HAMILTON COVE HOMEOWNERS ASSOCIATION CIVIL CODE SECTION 4765 HEARING 5/25/2022

DECISION OF THE BOARD OF DIRECTORS

FORBUSH CONCEPT DESIGN

Revisions After January 2021 Rejection

UPPER LEVEL

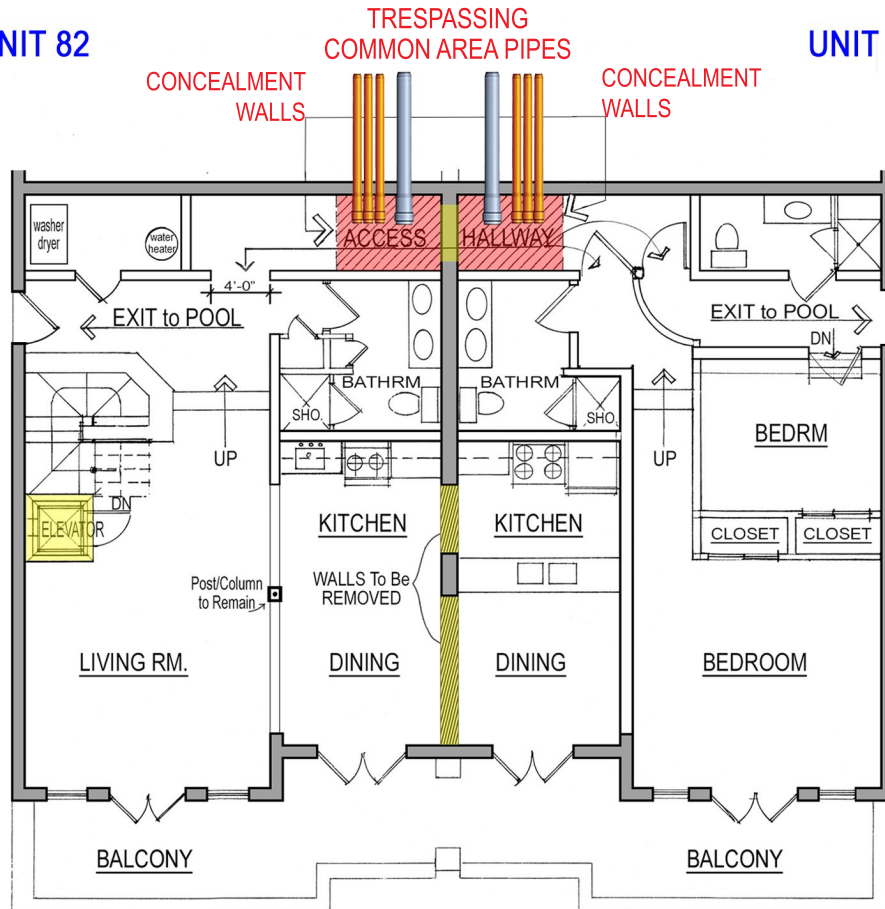
Request No. 2 is not approved. Installation of the Interior Elevator would involve eliminating the stairway between the first and second floors of the Unit. The proposed Interior Elevator involves modification of the second level floor joists and other structural issues.

Request No 6 is not approved. The request involves granting exclusive use of Common Area. Pursuant to Civil Code Section 4600, the Board lacks authority to grant such exclusive use. Applicants contend that the pipes are trespassing on the Unit. The pipes are not located within an area that is part of the Unit. They are located in a chute. Section 1.18 of the CC&Rs provides that “Common Areas shall include, without limitation, for maintenance purposes of the Association, but not necessarily by way of fee title, all gas, water and waste pipes, all sewers, all ducts, chutes, conduits, wires and other utility installations of the Project Improvements **wherever located.**” (Emphasis added)

Elevator access reduced by 50% with access between the upper and lower levels located in Unit 82 only.

Reduced hallway access where trespassing pipes are located - if pipes remain. Full recovery of owner-recorded square footage if pipes are removed.

Two Units opened to allow free access between them.

LOWER LEVEL

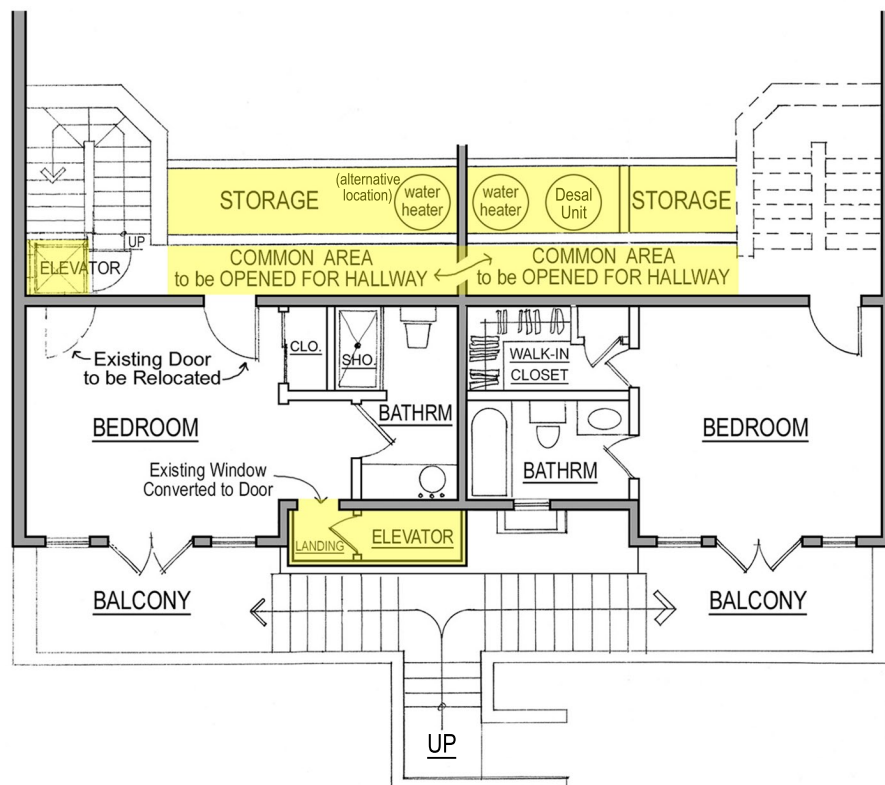
Request No. 1 is not approved. The Exterior Elevator would be located in Common Area and would require granting exclusive use of Common Area. The Board does not have authority to approve an exclusive use of Common Area as provided by Civil Code Section 4600 nor does the requested alteration come within the purview of any of the exceptions contained in said section. Additionally, Civil Code Section 4760(a)(2) applies only to the “member’s separate interest” and not to Common Area. The Exterior Elevator would alter the appearance of Building 8 inconsistent with the exterior appearance of the other buildings at Hamilton Cove. This does not meet the requirement of Section 4.02 of the CC&Rs which provides that any such exterior alteration “not be detrimental to the appearance of the surrounding area of Hamilton Cove as a whole, that the appearance of any structure affected thereby will be in harmony with the surrounding structures.”

Request No. 3 is not approved. The Association supplies salt water to all Units to be used solely to flush toilets. The Association’s saltwater system does not have the capacity to furnish saltwater for other purposes. In addition, the Association operates the sewer system on the Project which

interfaces with the Avalon sewer system. Adding highly concentrated brine to the sewage could jeopardize the system.

Desalinization unit added to aid in the supply of fresh water to the Units.

Exterior elevator entry now in Unit 82 only. (50% reduction)

Unit 82 bathroom remodeled to accommodate the elevator.

Unit 81 bathroom now unchanged, a 50% reduction in overall bathroom remodel.
